**Subject:** MHI's Responses to US-APWR DCD RAI No. 465-3382

Responses to Request for Additional Information No. 465-3382,  
Revision 1

**RAI NO.:** NO. 465-3382 REVISION 1  
**SRP SECTION:** 03.12 – ASME CODE CLASS 1, 2, AND 3 PIPING SYSTEMS AND PIPING COMPONENTS AND THEIR ASSOCIATED SUPPORTS  
**APPLICATION SECTION:** 3.12  
**DATE OF RAI ISSUE:** 10/06/2009

Fig.1 Briefing of Evaluation for the Structural Integrity

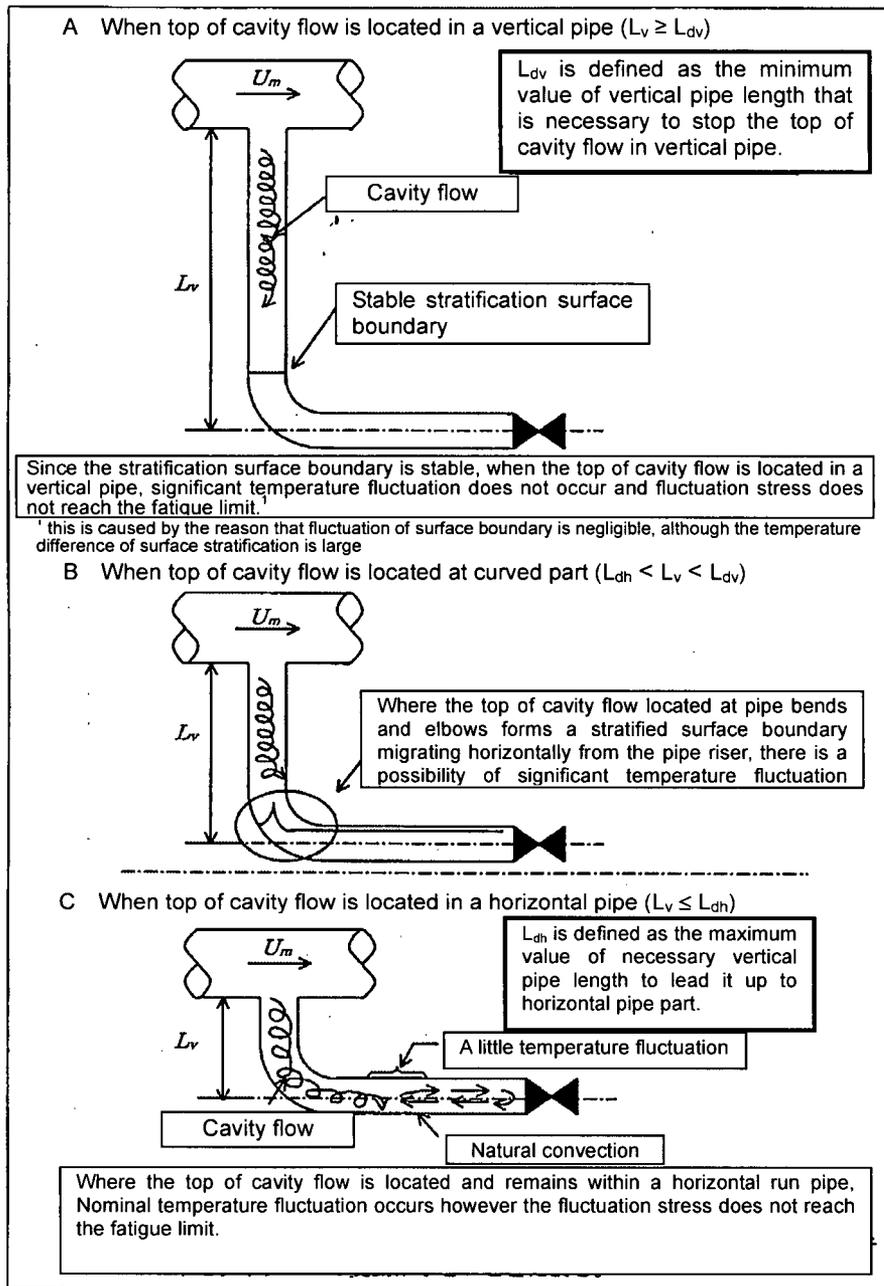
**QUESTION NO. 03.12-17:**

DCD 3.12.5.9 discussed thermal cycling in piping connected to the RCS. MHI's evaluation for thermal cycling is addressed by preventing valve leakage. The staff noted that valve-in leakage is not required for thermal cycling to occur in bottom-connected line, where thermal cycling occurs due to the cyclic penetration and retreat of the swirl flow in the branch line. The staff is requesting MHI to identify and address thermal cycling for bottom-connected lines.

In response to Question No. 03.12-10, (RAI 260-2023, MHI Ref: UAP-HF-09168, dated 4/17/2009, ML091110309) MHI stated that installation of double isolation valves decreases the possibility of leakage to the downstream of the isolation valves, which results in prevention of thermal stratification or oscillation. However, this does not ensure that leakage would not occur. Explain if any other activity could detect this low possibility leakage before causing any thermal stratification or oscillation.

High temperature water flow that flows as a series of swirls is referred to as "cavity flow." This phenomenon occurs from the RCS pipe run to each stagnant branch line isolated by a valve. In addition, stratification at the surface boundary occurs between the high temperature water entering the branch pipe and the low temperature water already in the branch. When the stratified surface boundary (top of cavity flow) occurs at horizontal pipe bends and elbows, there is a possibility of significant thermal fluctuation inducing high-cycle thermal fatigue at this point (refer to Fig. 1, case B). As a result, the US-APWR pipe routing is made such that the stratified surface boundaries are not located at horizontal pipe bends and elbows along isolated branch pipes connected to the RCS.

As a prediction method, the piping route design is conducted such that the position of the stratification surface is not located at bending pipes and elbows migrating horizontally from vertical risers, based upon the evaluation models of cavity flow penetration length which is established based on test data conducted domestically in Japan. The subject research results have become publicly known at the 10th and 11th International Conference on Nuclear Engineering (refer to ICONE10-23340 and ICONE11-36214).

Furthermore, as verification of actual equipment, confirmation is made such that there is no stratification surface boundary (top of cavity flow) at pipe bends and elbows migrating horizontally from vertical risers by performing temperature measurement for actual equipment of isolated branch pipes around RCS during initial startup test.

The safety-related parts which apply double isolation valves from RCS are shown in Table 1 (downstream of RV vent line, excess letdown line, Cavity/RCS water level meter line and loop drain line are not safety-related.) If there is leakage from RCS to the downstream of these parts, the leakage can be detected by the instruments shown in Table 1.

Add the following as the last paragraph in Subsection 3.12.5.9:

“Furthermore, high temperature water that flows from the RCS pipe run into isolated branch pipes occurs as swirling water, referred to as cavity flow induced by the high temperature pipe. In addition, there is a phenomenon in which stratification occurs at the surface boundary between the high temperature water entering the branch pipe and the low temperature water already in the branch. When the stratified surface boundary (top of cavity flow) occurs at horizontal pipe bends and elbows, there is a possibility of significant thermal fluctuation inducing high cycle thermal fatigue at this point. Therefore, the piping is routed such that a stratified surface boundary does not occur at horizontal pipe bends and elbows.”
